ADDENDUM NO. 1 - OUTLINE AND SUMMARY INFORMATION

Project Name: Renne Library Northside Window Upgrades PPA No.: 22-0601
Location: Montana State University - Bozeman Date: April 1, 2026

REM02 – DETAILS 1 AND 2 – BASE SCOPE – SECOND FLOOR – ACM NOTES:

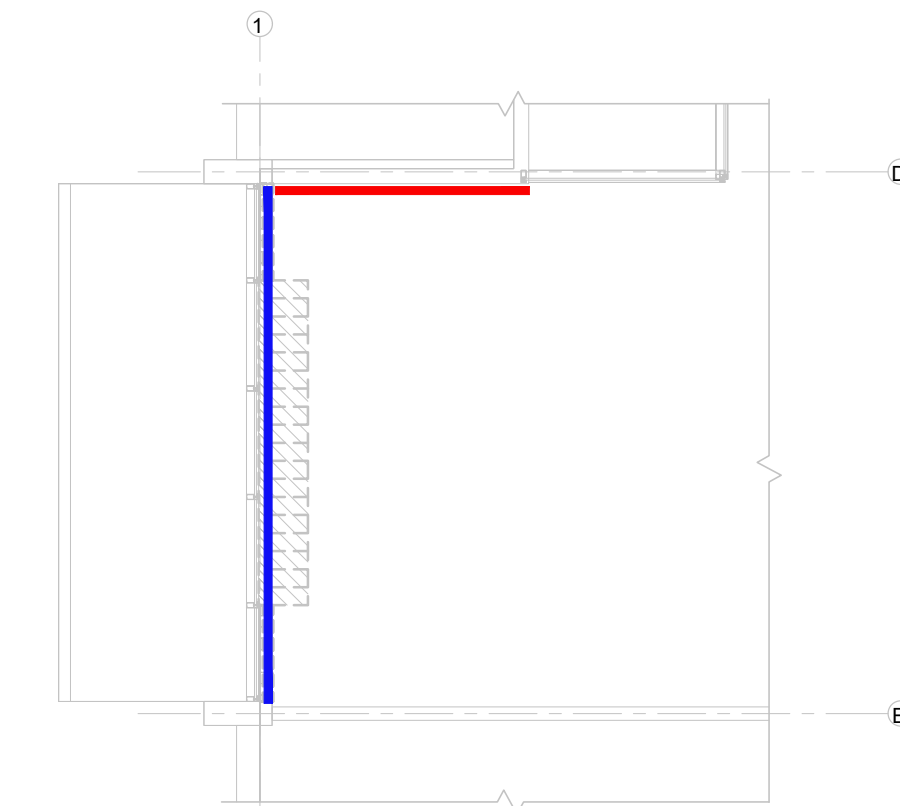
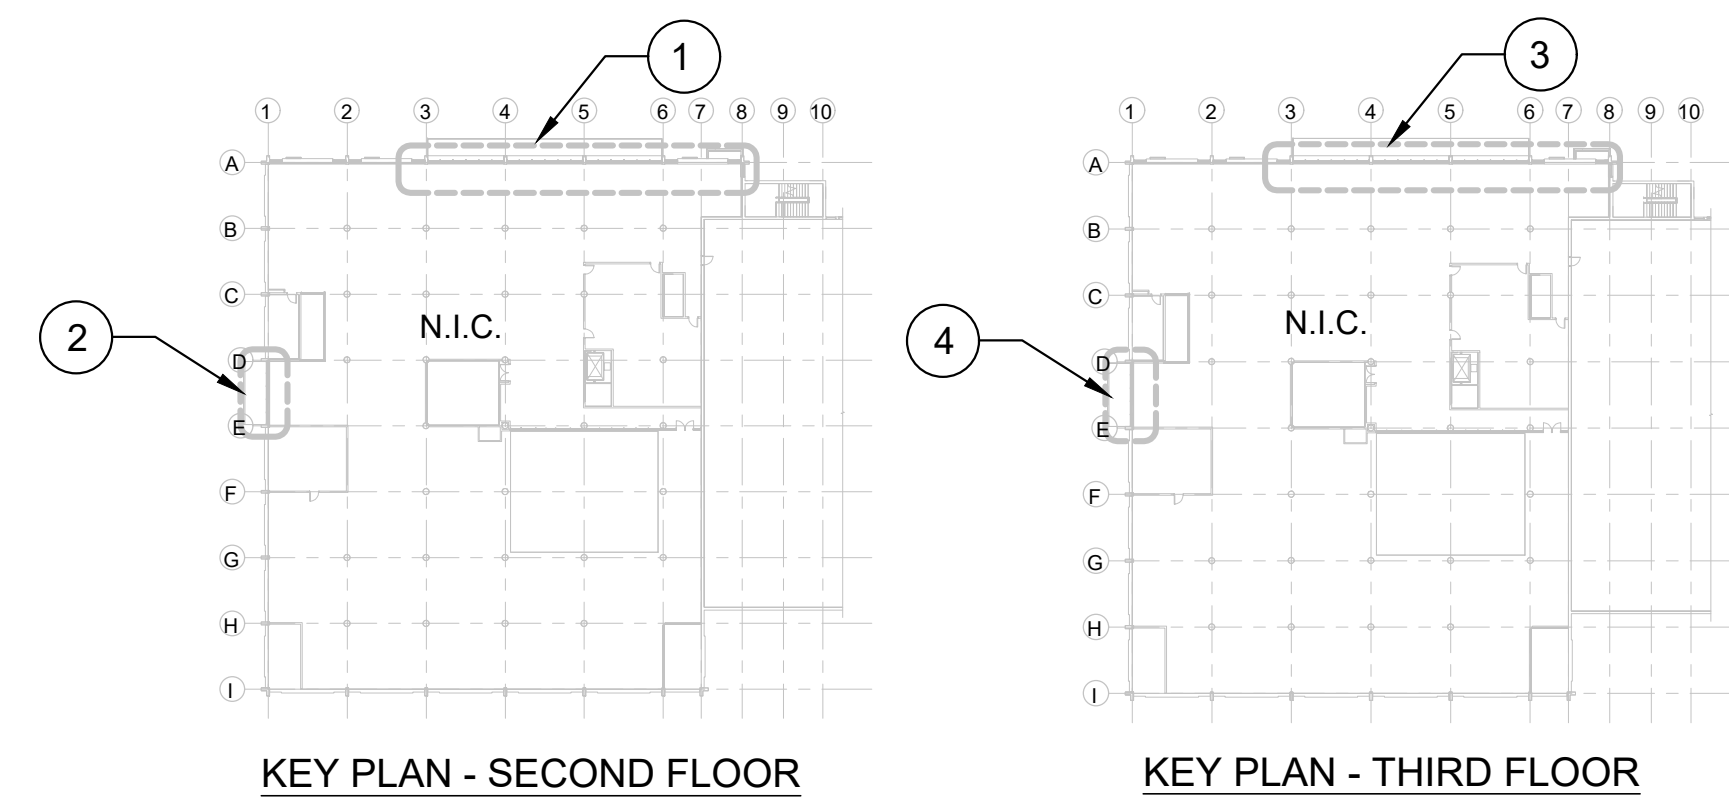
- e. Sheet REM02 Legend M2.1 states the tan caulk around window is expected to be impacted by window replacement. Please confirm all windows are to remain.
 1. **Response:** Existing windows are to remain. Contractor to ensure remediation work does not damage existing building elements that are to remain.

LEVEL 2 DEMOLITION PLAN - NORTH

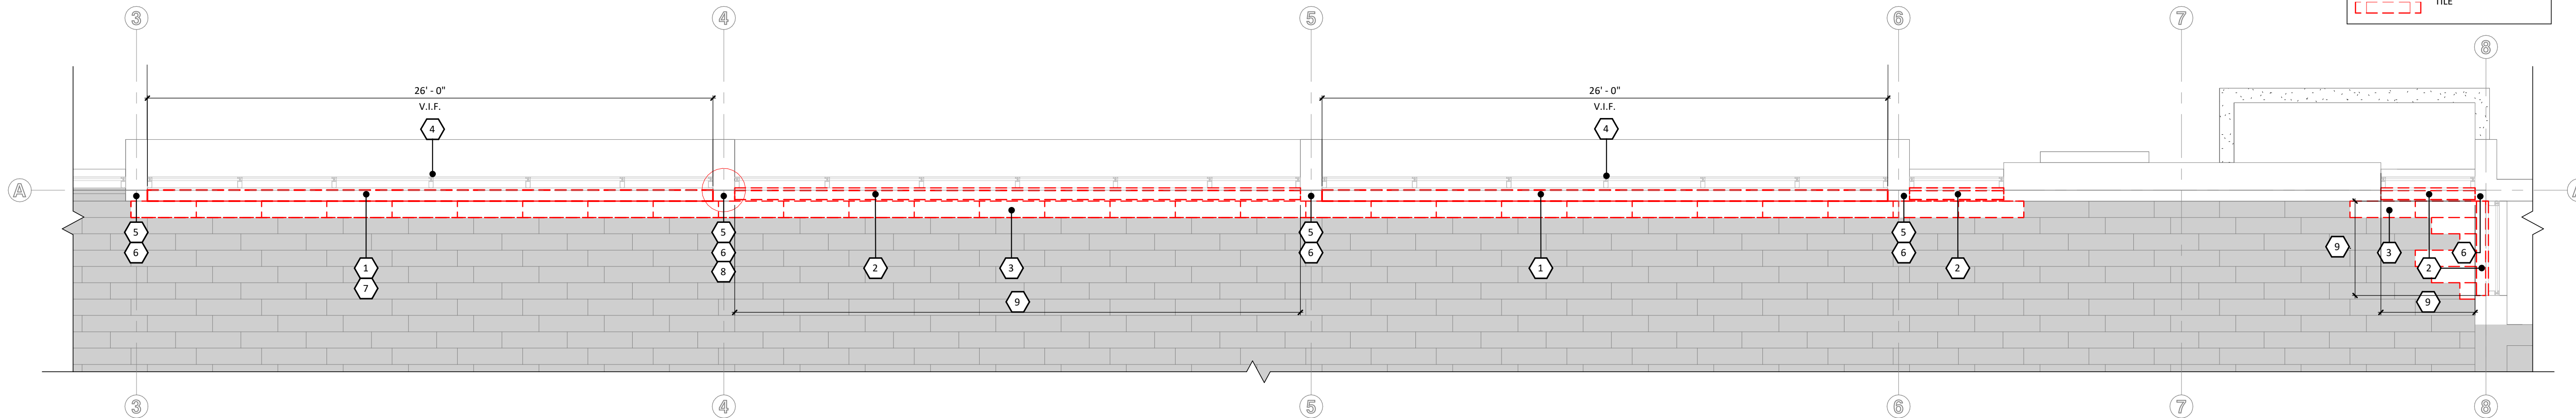
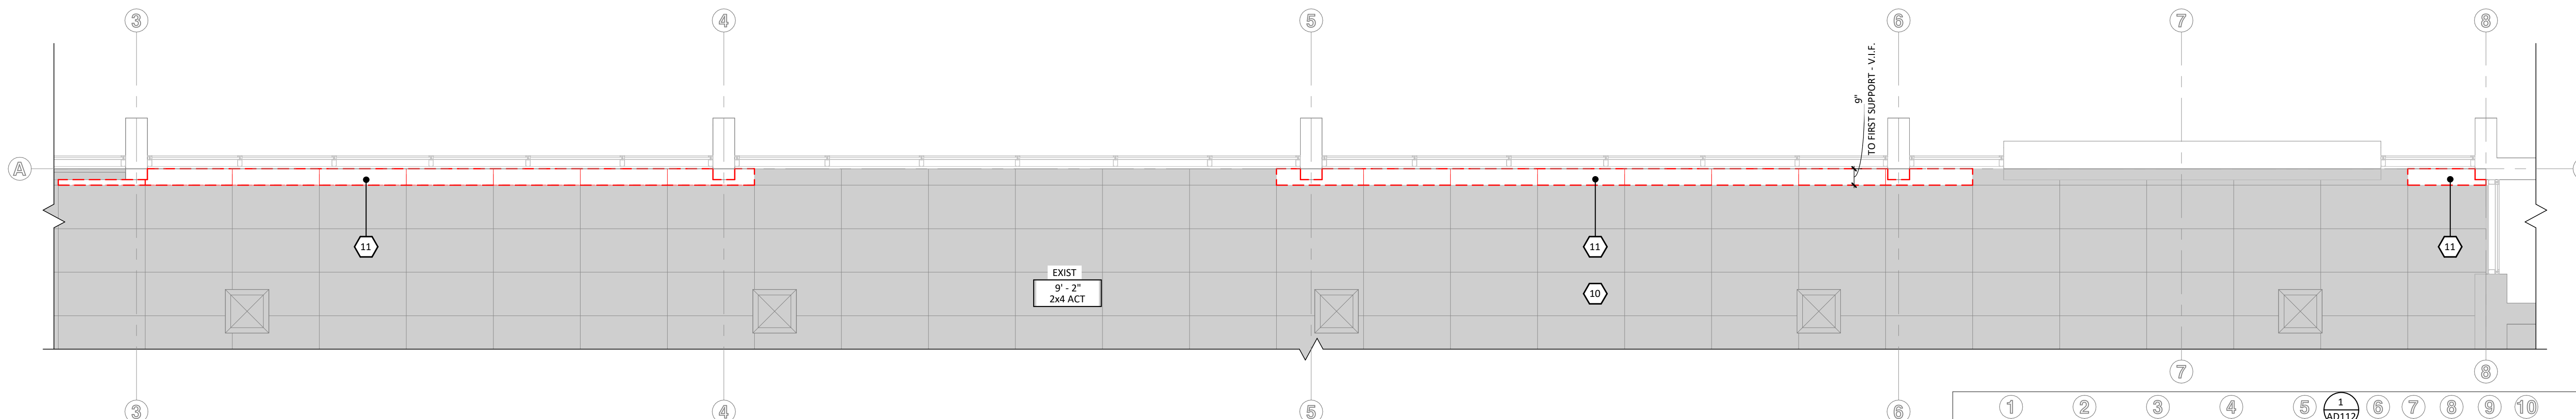
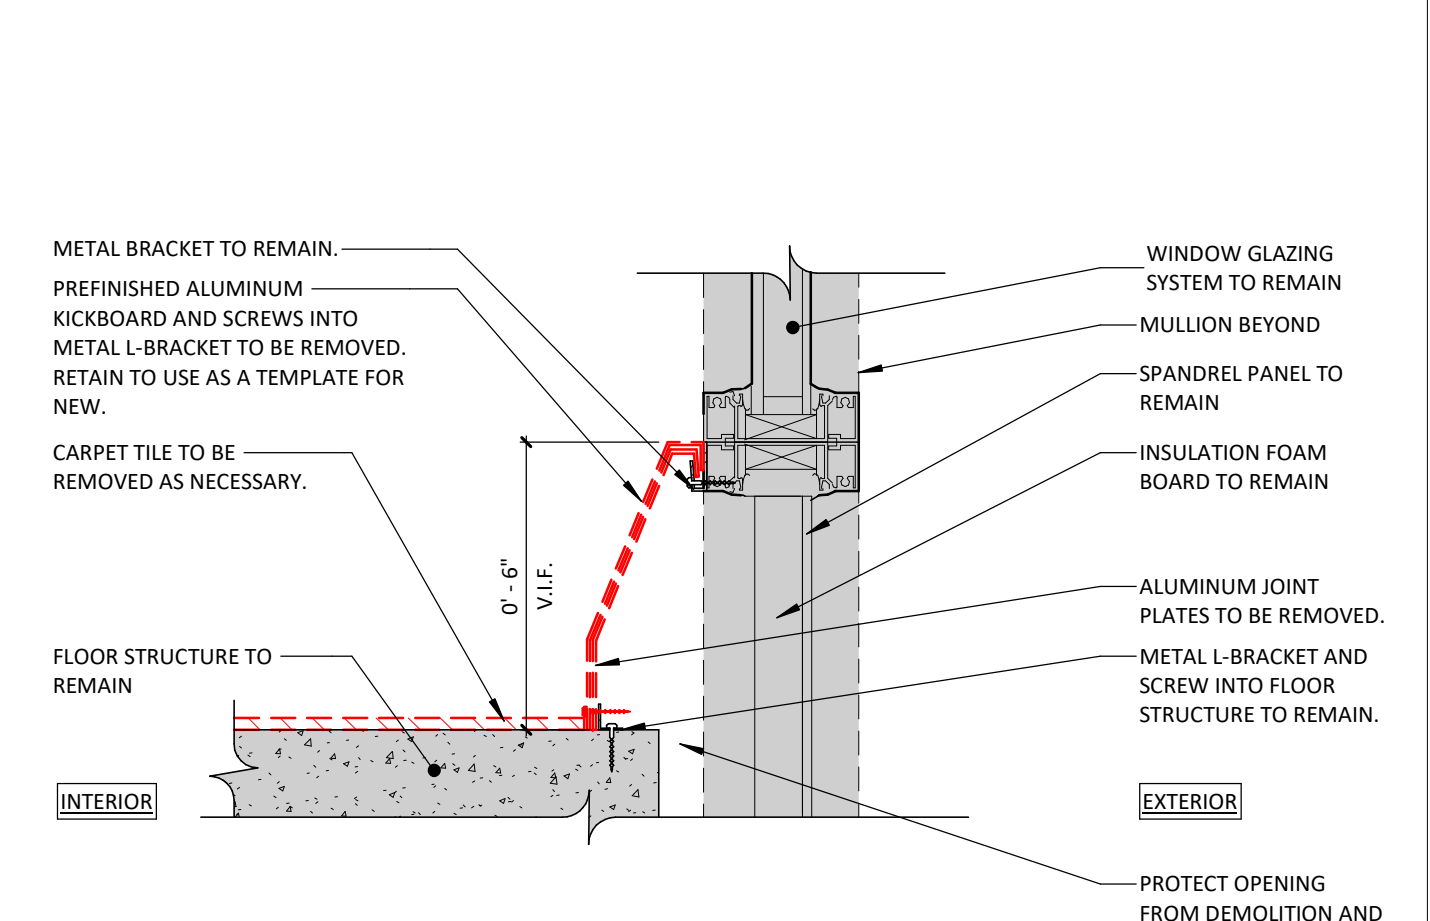
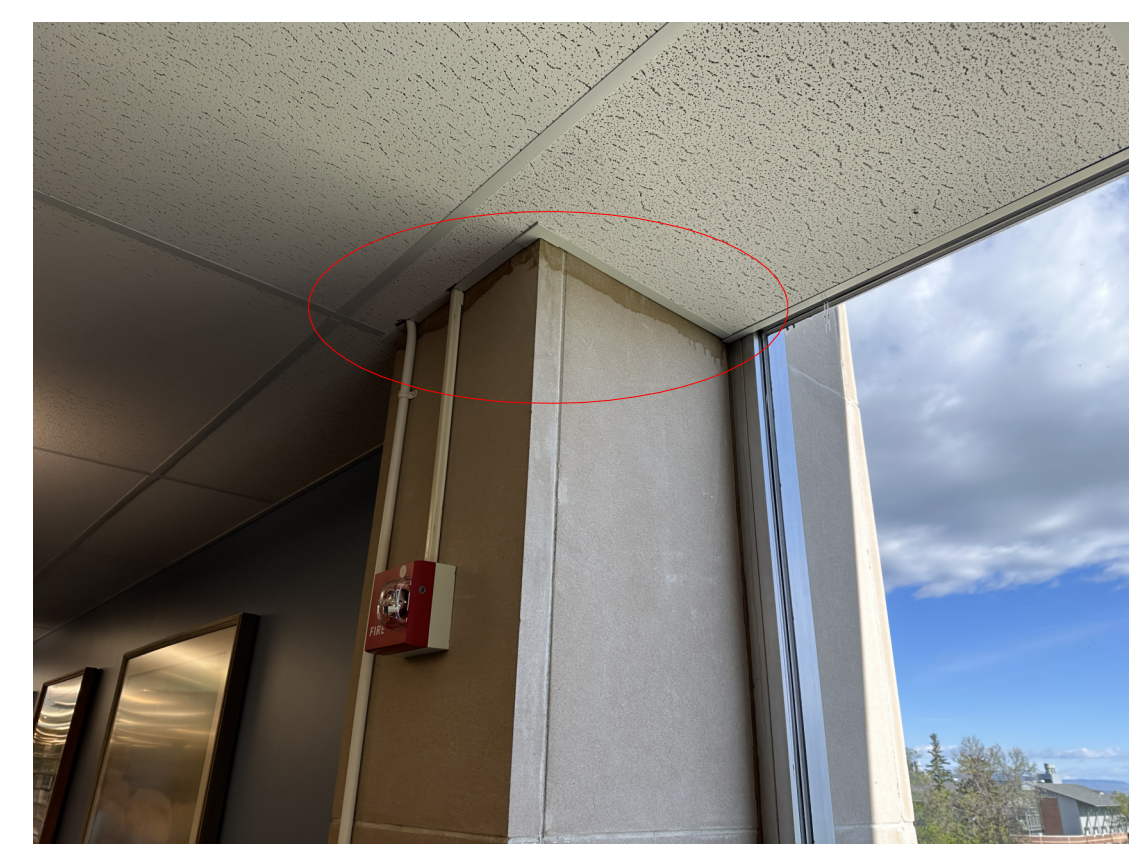
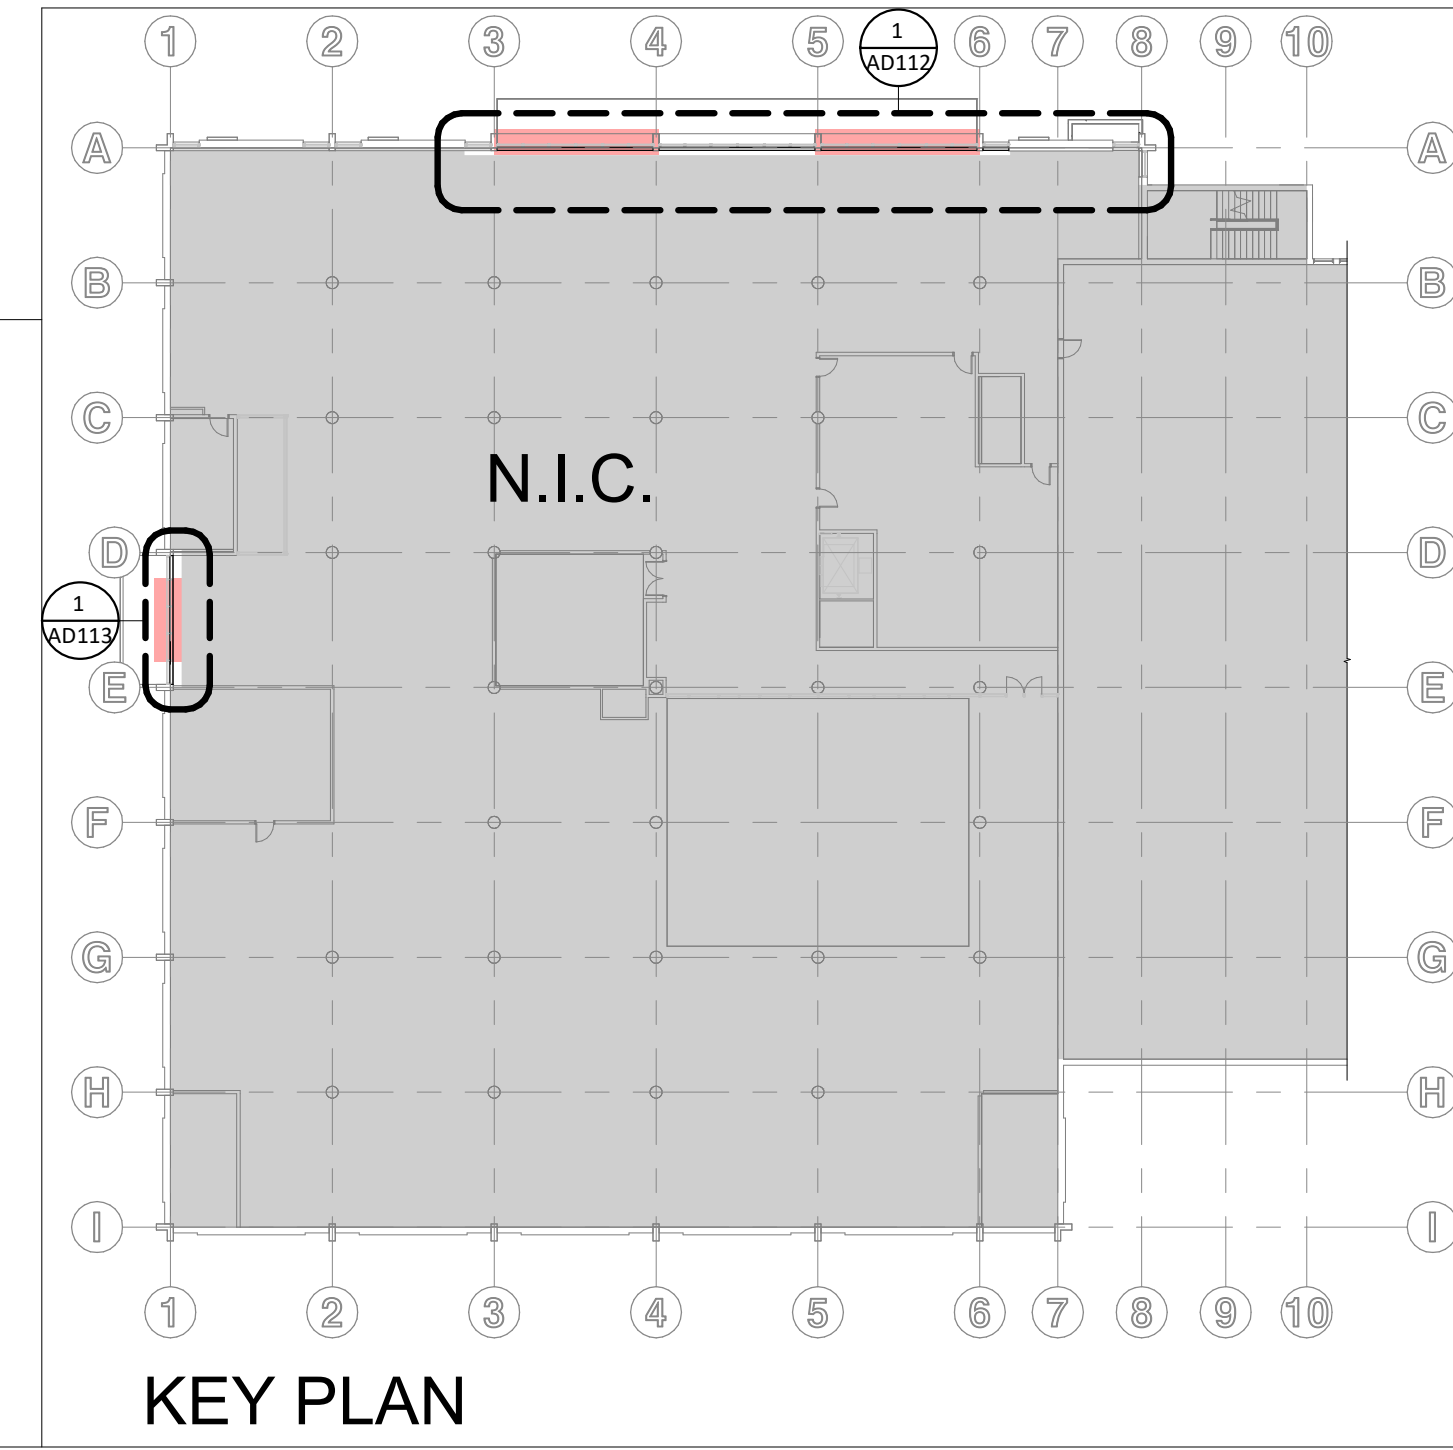
a. SHEET AD112 – DEMO KEYNOTES AD112 (NOTE 6):

- h. Sheet AD112 note 6 states staining at top of concrete columns at ACT Frame. Remove ACT and clean using Prosoco Safety Peel. Please confirm staining is a result of paint.

CHANGE to: STAINING AT TOP OF CONCRETE COLUMNS AT ACT FRAME. CAREFULLY REMOVE ACT CEILING TILES AND FRAME AS NECESSARY FOR FULL EXTENT OF CLEANING. CONTRACTOR TO REMOVE STAINING FROM COLUMNS WITHOUT DAMAGING EXISTING MATERIALS.

1. **Response:** Contractor to remove staining from columns without damaging existing and adjacent materials. Prosoco Safety Peel 1 product has been stricken.
